TO: Bede Morrissey, Policy Planner, City Development

FROM: Logan Copland, Trevor Watson, DCC Transport

SUBJECT: **VARIATION 2: TRANSPORT RESPONSE TO REQUEST FOR COMMENTS ON GREENFIELD REZONING SITES – REJECTED SITES**

RS110: 23 Sretlaw Place / 118 Brockville Road – Rezoning from Rural to General Residential 1

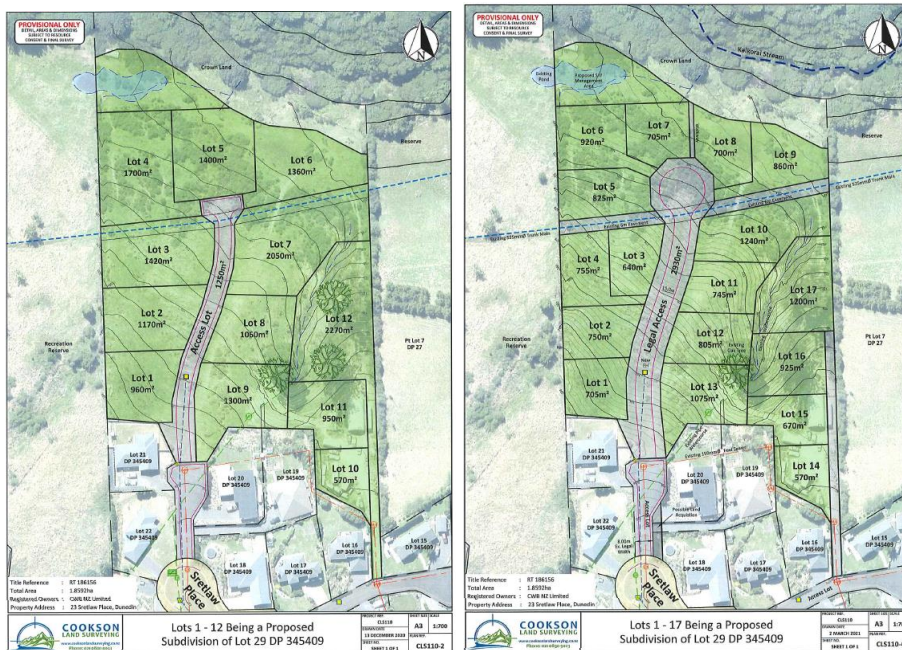
30. Plan CLS110-2 (left) shows 3 lots accessed over 18 Sretlaw Place and 9 lots accessed over 25 Sretlaw Place, both of which appear to be shared access lots.

31. Plan CLS110-4 (right) shows 4 new lots access over 18 Sretlaw Place and 13 new lots accessed over 25 Sretlaw Place, and hence, is essentially an up-scaled version of CLS110-2.

32. There appears to be 4 existing users of the access over 18 Sretlaw Place and 10 existing users of the access over 25 Sretlaw Place. Hence, the development could increase these numbers to up to **17** over 25 Sretlaw Place and **14** over 18 Sretlaw Place.

33. These access lots are not of a standard that Council would accept to adopt as legal roads. For this to happen, they would need to be widened/upgraded to Code of Subdivision standards as part of a subdivision and vested back to the Council as legal roads. This would require agreement from other owners/users.

34. Increased use of these access lots of private access-ways to the numbers being contemplated would be contrary to recent policies notified relating to number of lots accessed from a private way (where it is suggested that an access-way serving more than 12 sites should be made a legal road).

RS205: 761 Aramoana Road – Rezoning from Rural to Township and Settlement

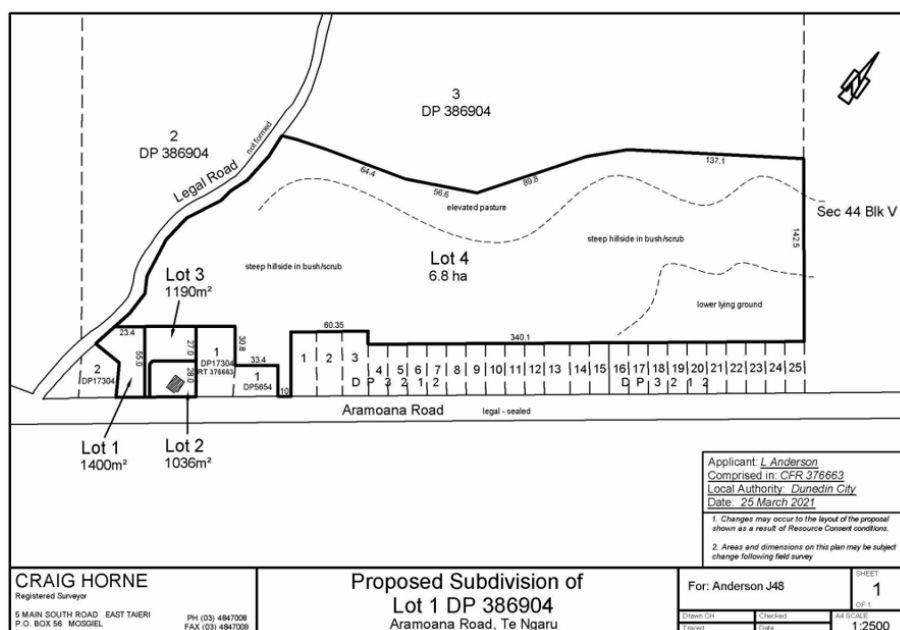
80. An additional 3 residential sites would have an insignificant impact on the transport network. Any existing issues with the transport network would not be exacerbated to any noticeable extent because the scale of development being considered is small.
81. That said, access to the new sites would need to be assessed by the developer at the time of subdivision and confirmed as complying with minimum sight distances requirements in the 2GP.

Figure 1 : Proposed Re-Zone Site Structure Plan

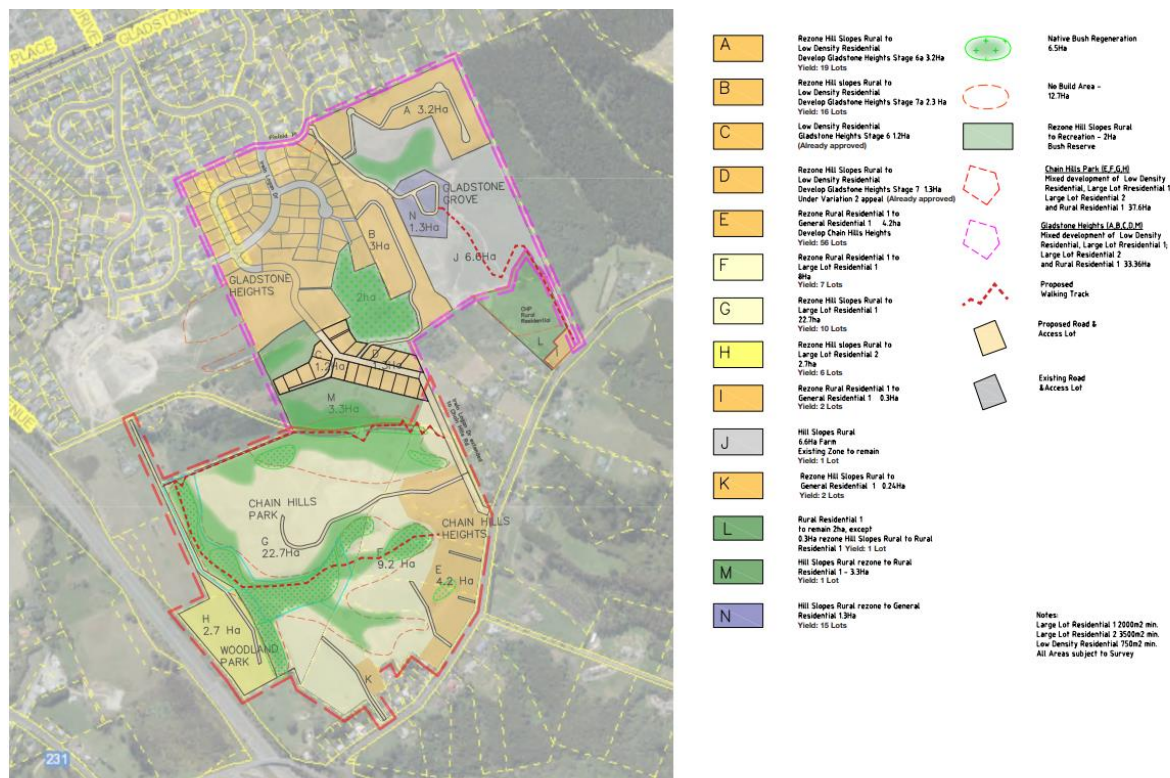
86. FS105 opposes the change and specifically notes that they oppose the proposed road connection from Gladstone Road North to Chain Hills Road due to safety concerns.

87. FS107, FS108, FS118, FS246, FS26, FS46, FS48 and FS165 oppose the change primarily due to concerns about the road connection. They consider that Chain Hills Road and Morris Road are currently unsuitable to accommodate the change. FS165 notes that there are no pedestrian or cycle facilities on Chain Hills Road and suggests that the developer should be required to construct a cycle and pedestrian path at least along the area where the proposed road will join Chain Hills Road and the junction with Morris Road, and provide for a dedicated cycle lane along Morris Road and possibly Main Road as far as the Old Brighton Road turnoff. They also consider it is questionable to promote cars leaving the motorway at Fairfield to reach Mosgiel because they would need to pass the Fairfield Primary School.

89. FS89 opposes the submission, but in particular opposes the road connection between Gladstone Road North and Chain Hills Road. They comment that the Irwin Logan Drive / Gladstone Road North intersection will 'become an increasing bottleneck'. They consider that this intersection would require a roundabout. They also raise concerns about more traffic turning right from Irwin Logan Drive into Heathfield Drive and associated effects on the safety and efficiency of Gladstone Road North.

95. As can be seen from the submitter's concerns, the submission proposes a roading link between Chain Hills Road and Gladstone Road North. This would occur via an extension of Irwin Logan Drive, which passes through the Gladstone Oaks development and has continued through the more recent Gladstone Heights development.

96. Chain Hills Road extends from Morris Road and terminates at a dead end after a length of about 3.4km. The proposed new intersection with Chain Hills Road is shown to be located about 800m north of the Morris Road intersection and hence, this section of Chain Hills Road would receive additional demand should the connection proceed. The proposed intersection location would require assessment against Austroads. This would need to be done by the developer's traffic engineer and submitted to Council for review.

97. Many submitters raise concerns with respect to the safety implications of the development on Chain Hills Road. They note that the road is a rural road with an 80kph speed limit with a tortuous alignment and lack of facilities for non-motorised road users. I concur with the concerns raised by the further submitters and consider that the proposer should be required to address these concerns.

100. In that regard, Transport recommends that an integrated transport assessment is prepared by a suitably qualified and experienced person. This will need to include an analysis of traffic generation, but also distribution of existing and new traffic which could be changed with the proposed roading connection. This will allow the Council to better understand the scale of the potential wider effects of the connection on the wider transport network. For example, the connection could be used as a rat-run for drivers wishing to bypass the SH87 intersection which is commonly understood to be under significant pressure during peak hours. This could funnel additional traffic through Fairfield, accessing/egressing the motorway via Old Brighton Road. As above, in the absence of any detailed transport assessment / traffic modelling, the scale of this potential problem is not understood to a point where the Council is able to make a conclusive determination on Transport rounds as to the acceptability (or otherwise) of the development at this stage.
